Project No. 16151-01

SUBJECT: Engineering Geologic Report/Response to City Review Comments, Proposed 70 Lot Single Family Residence Development, Tract 36911, City of Menifee, California

SUBJECT: LIMITED ENGINEERING GEOLOGIC REPORT & RESPONSE TO CITY
COMMENTS, Proposed 70-Lot Tract 36911, Menifee, California
SEC Project No. 16151-01, RGS Project No. 1740-01

9.0 DETAILS

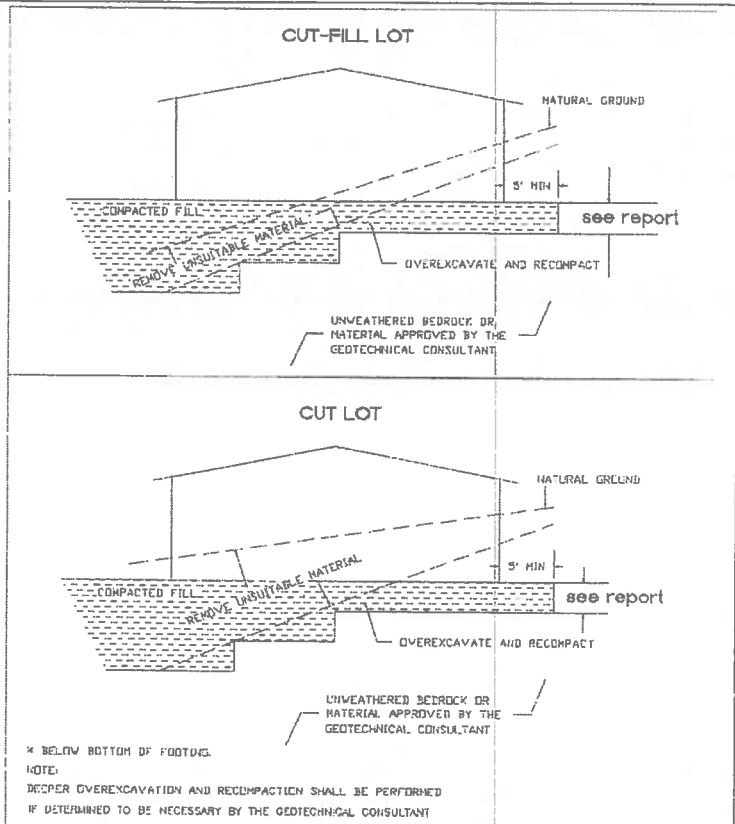
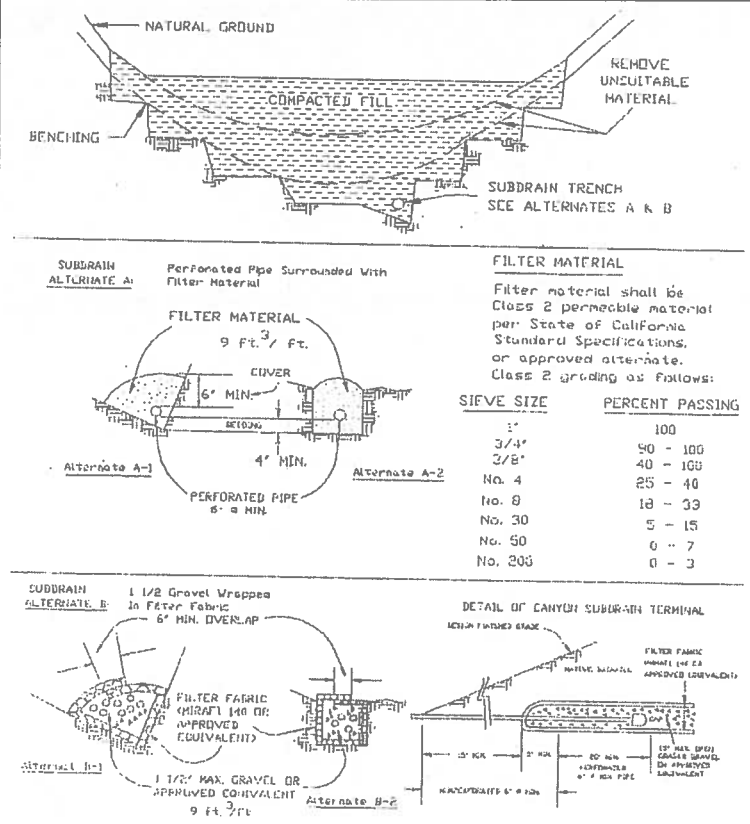
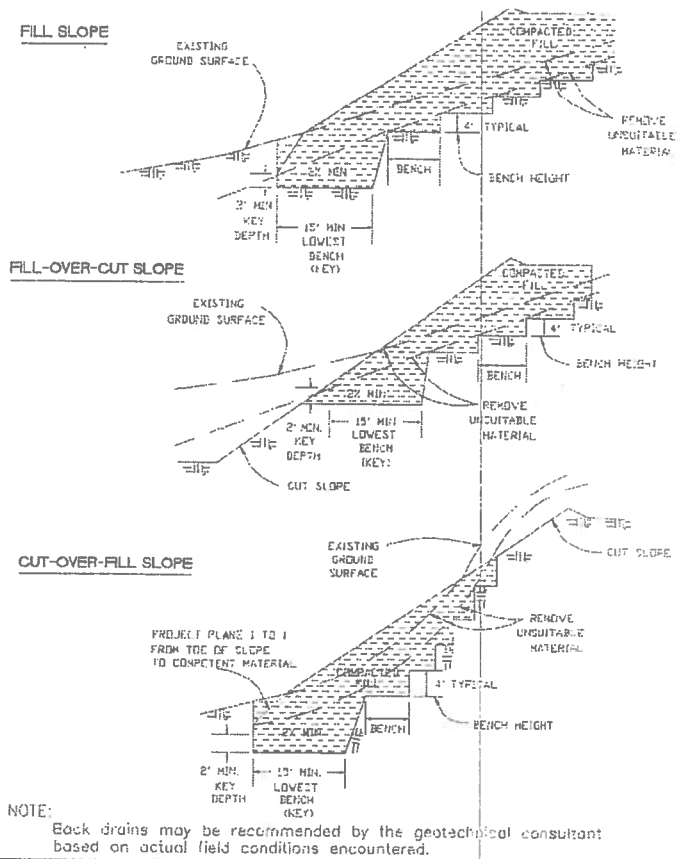
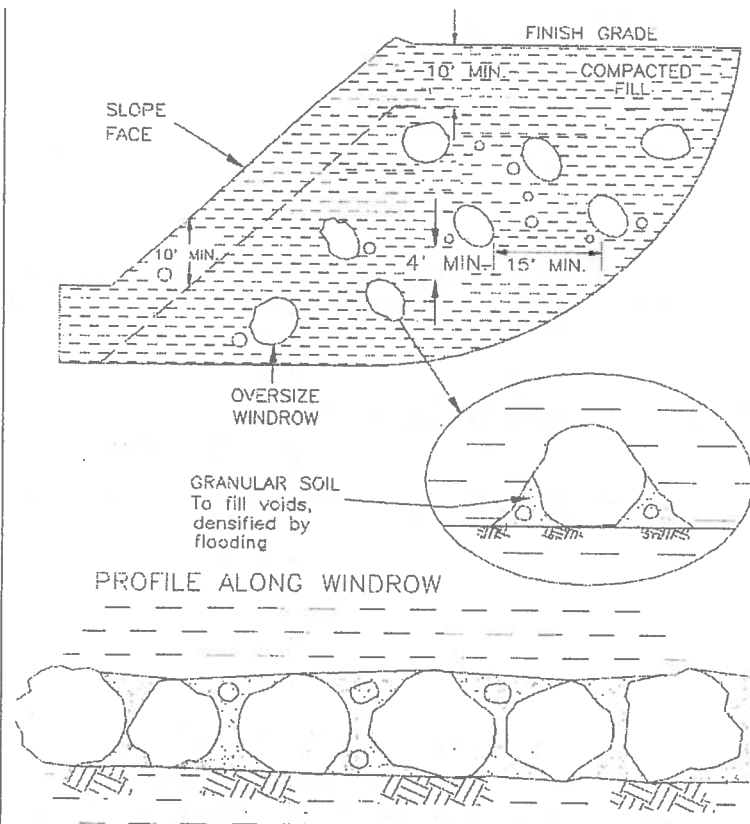
Comment 6 - On page 3 under the section titled, "Conclusions", the report discusses on site soils and their suitability for use as engineered compacted fills:

Oversized materials can be placed as decorative rock at designated locations, exported from the site or placed in windrows per detail in our General Earthwork and Grading Specifications (Appendix E) of the referenced report. The detail is attached herein for easy reference.

Figure 4

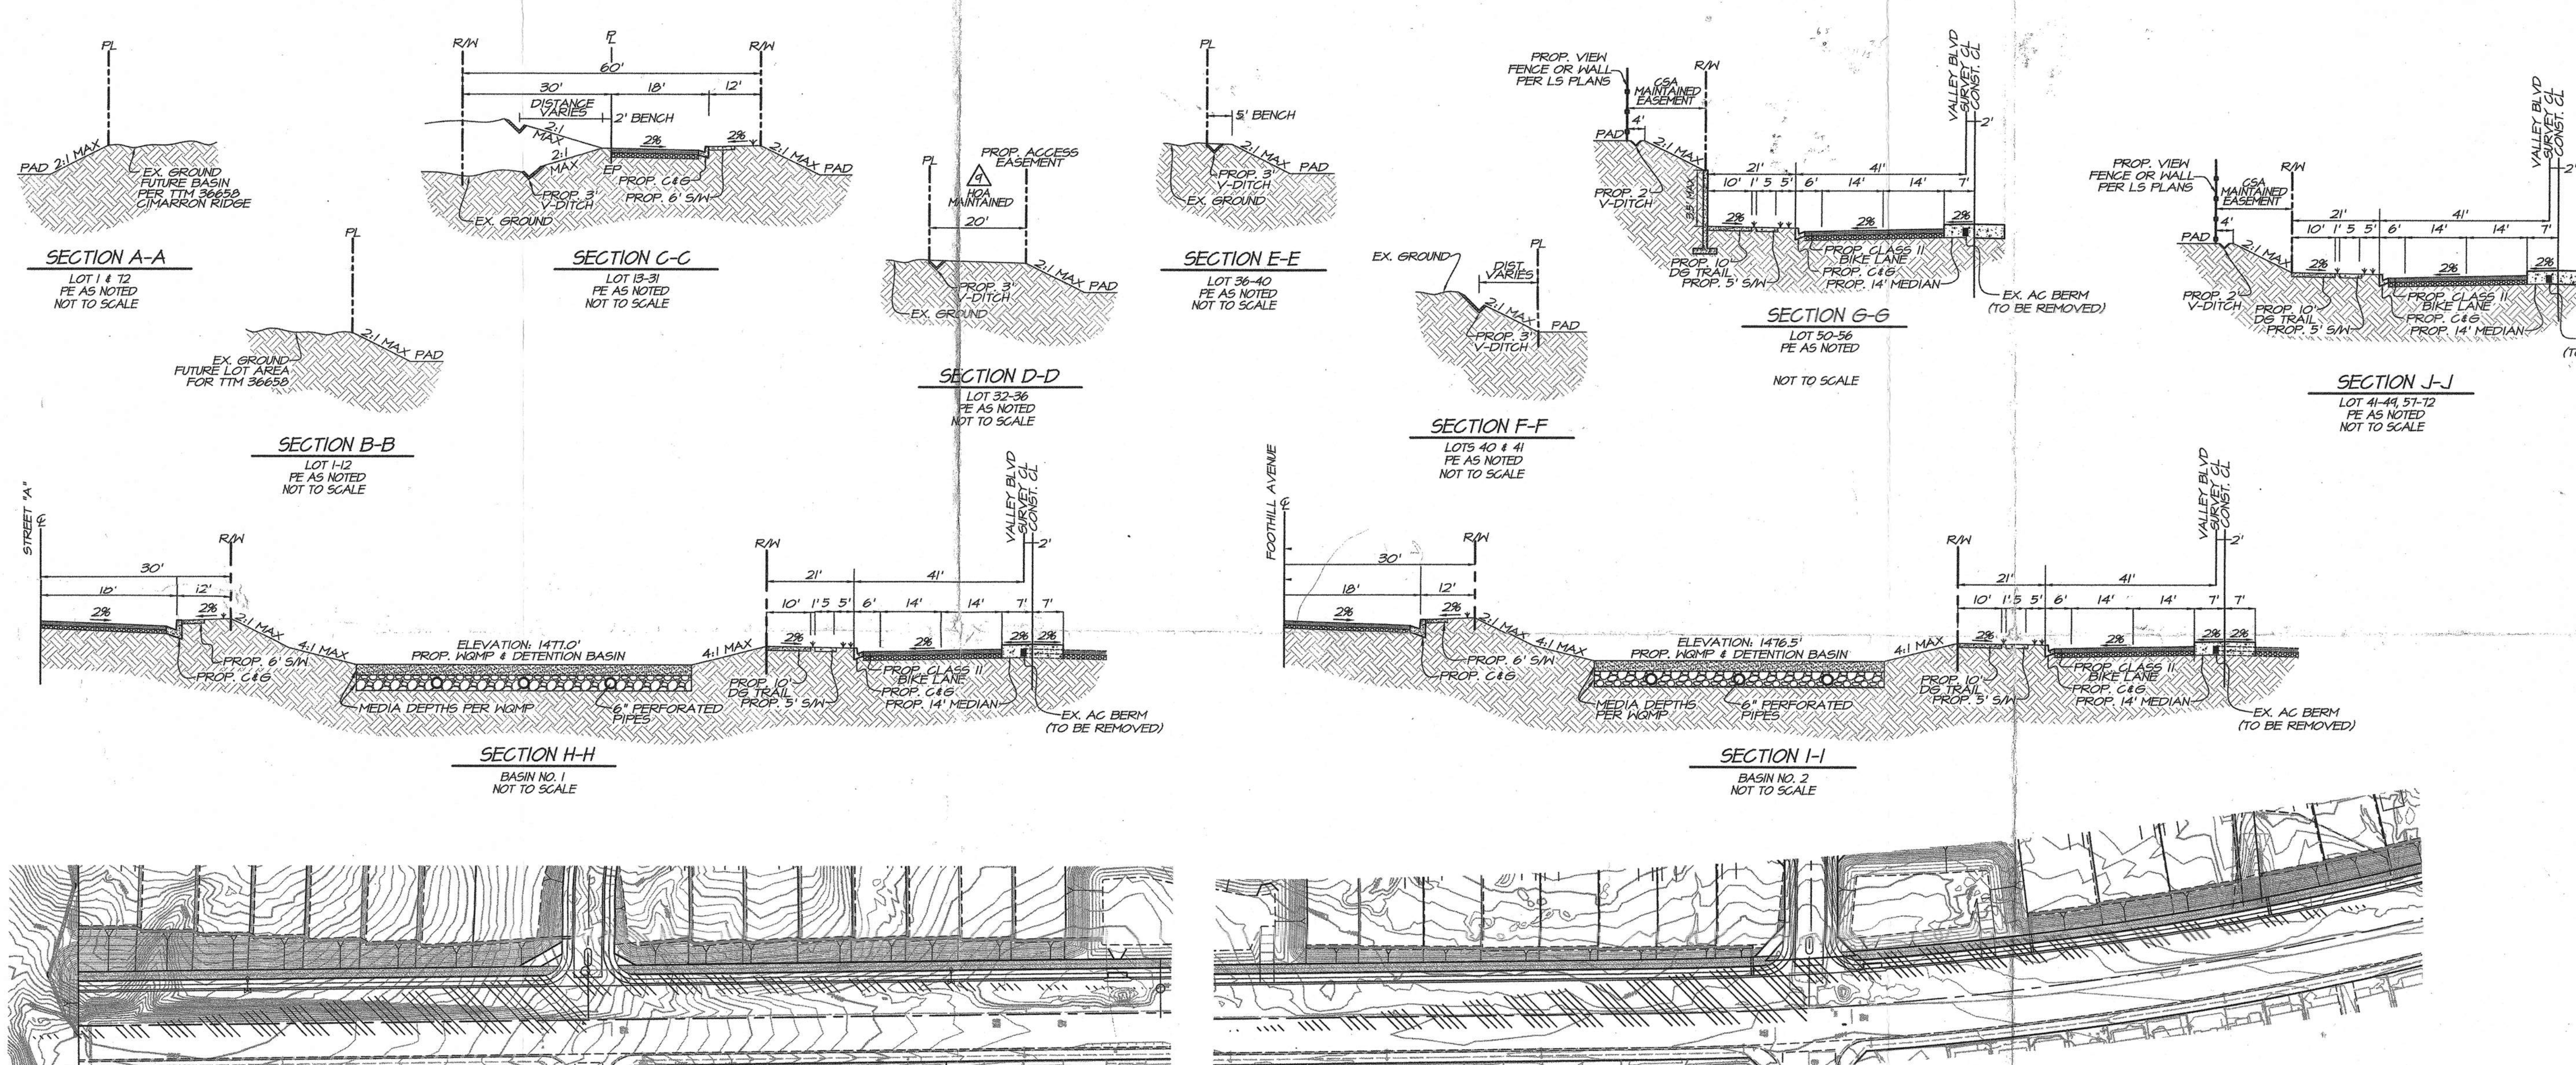
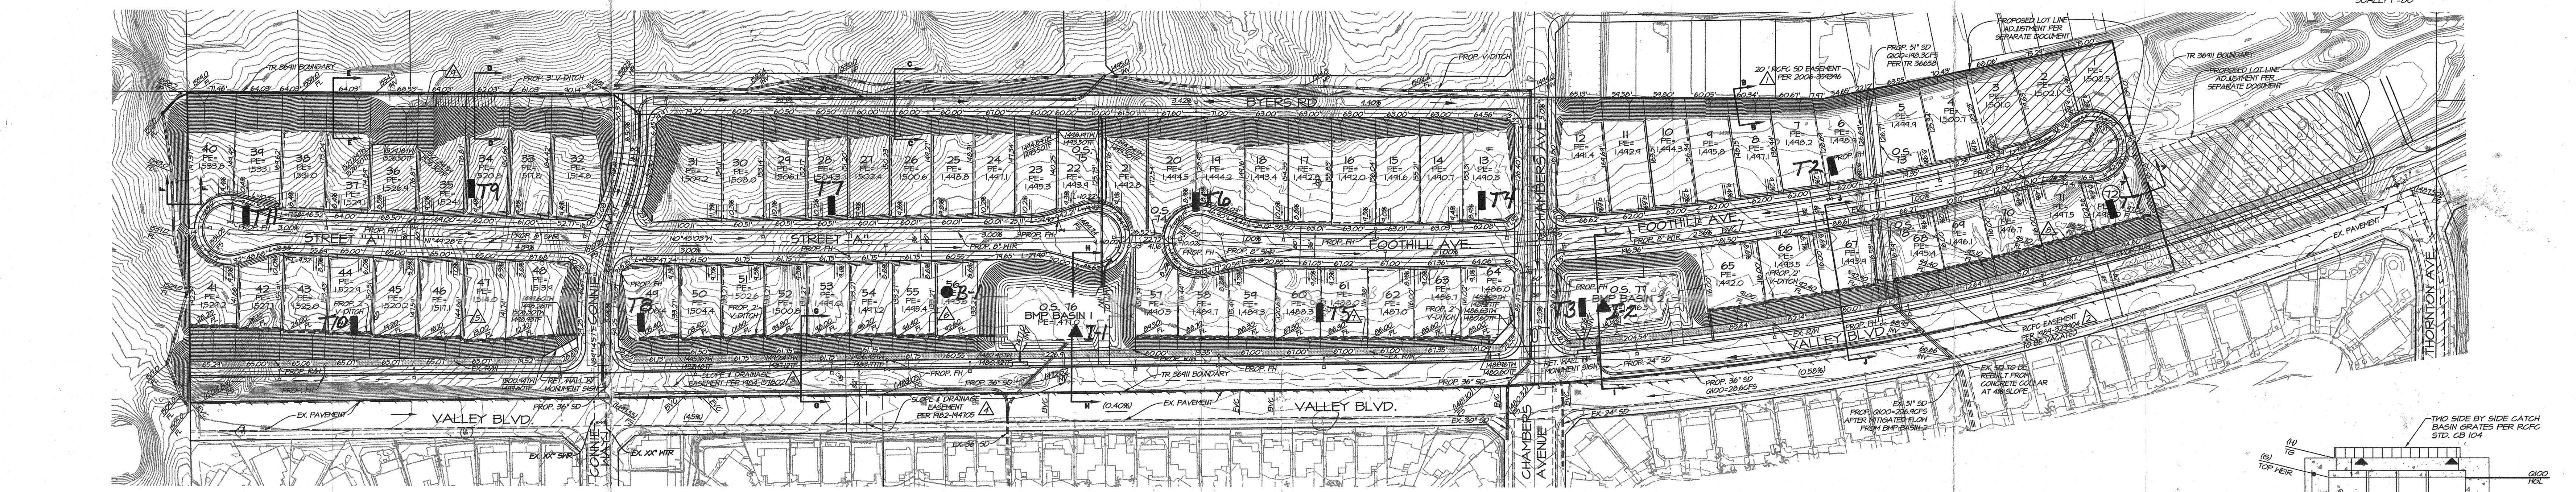
The referenced project report that was submitted for our review did not have a site specific geologic map. Figure 2 of that report was a copy of a portion of the USGS geologic map and did not have a scale or a north arrow. Figure 4, Fault Activity Map of California, did not have a scale or a north arrow. Plate 1, Exploratory Trench, Boring and Infiltration Test Location Map, did not have a legend, and the locations of the exploratory trenches were barely legible.

Legible map (Plate 1) and Figure 4 with North arrow and scale in response to Comment 4 are included in pocket and attached.
